SOUTHERN ILLINOIS POWER COOPERATIVE IMPOUNDMENT INFORMATION

INSPECTION REPORT

SOUTH FLY ASH POND DAM

DAM INSPECTION REPORT

PHOTO DESCRIPTION

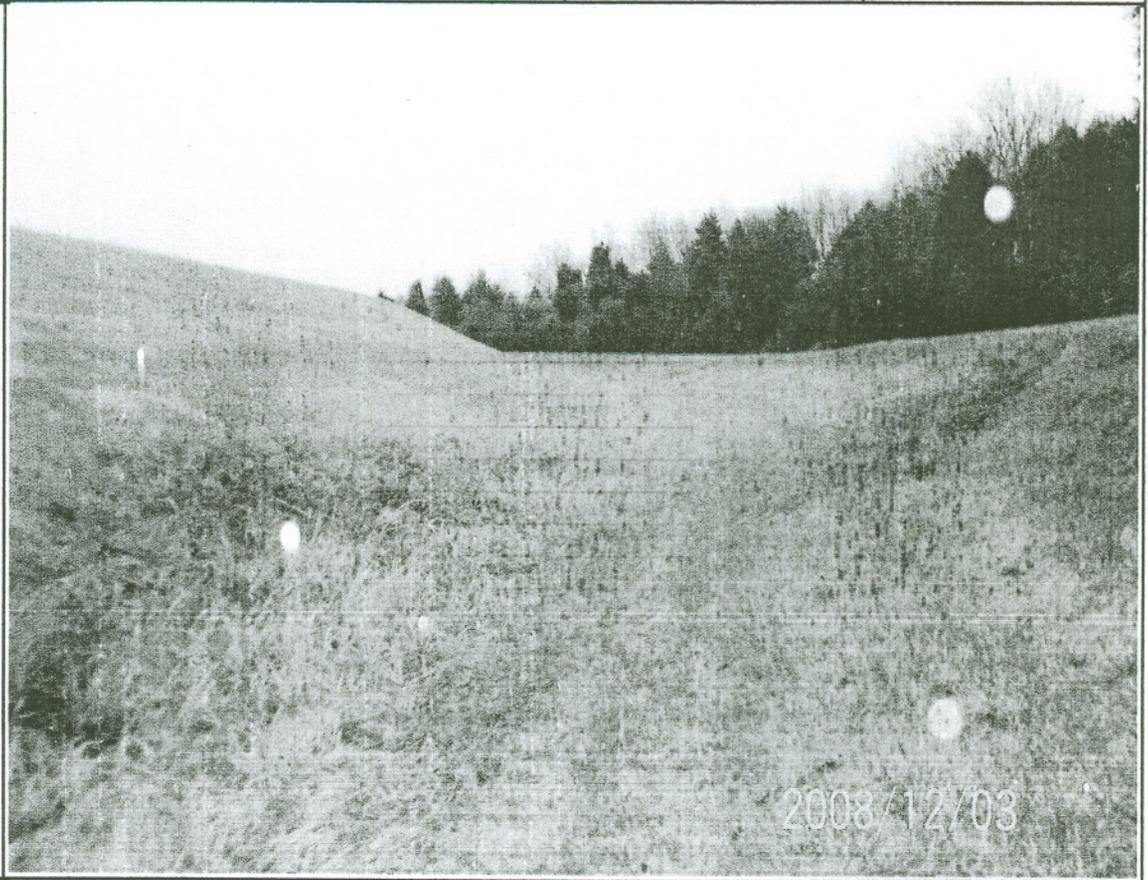
ITEM	CONDITION	DEFICIENCIES	RECOMMENDED REMEDIAL MEASURES AND IMPLEMENTATION SCHEDULE
Animal Damage	N.E.		
Embankment Drainage Ditches	M.M.	Downstream drainage ditch standing water	Investigate the cause. Re-grade ditch to get to drain. Re-inspect to ensure there is no seepage.
Vegetative Cover	G.C.		
Other (Name)			
Other			
Other

Looking at area needing
grading.

PHOTO DESCRIPTION

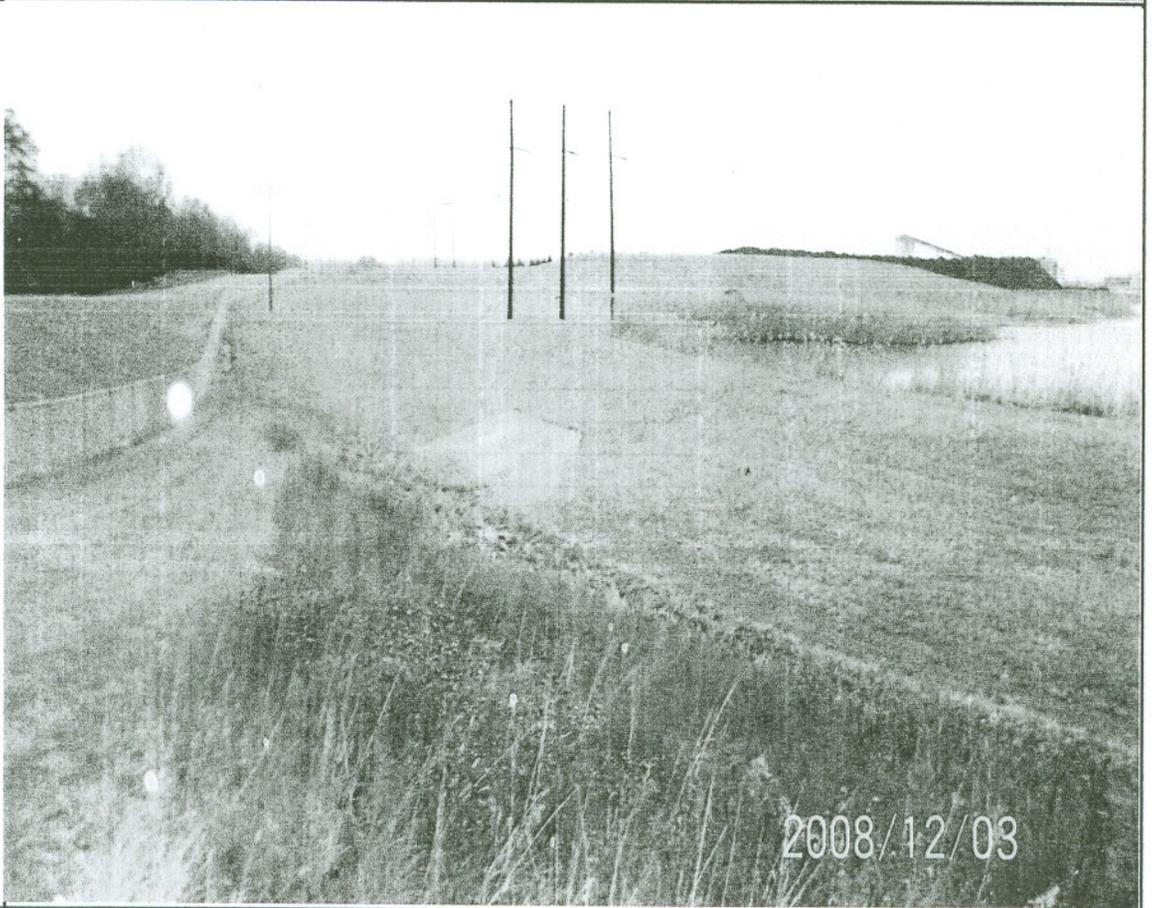
Looking west at area
needing grading
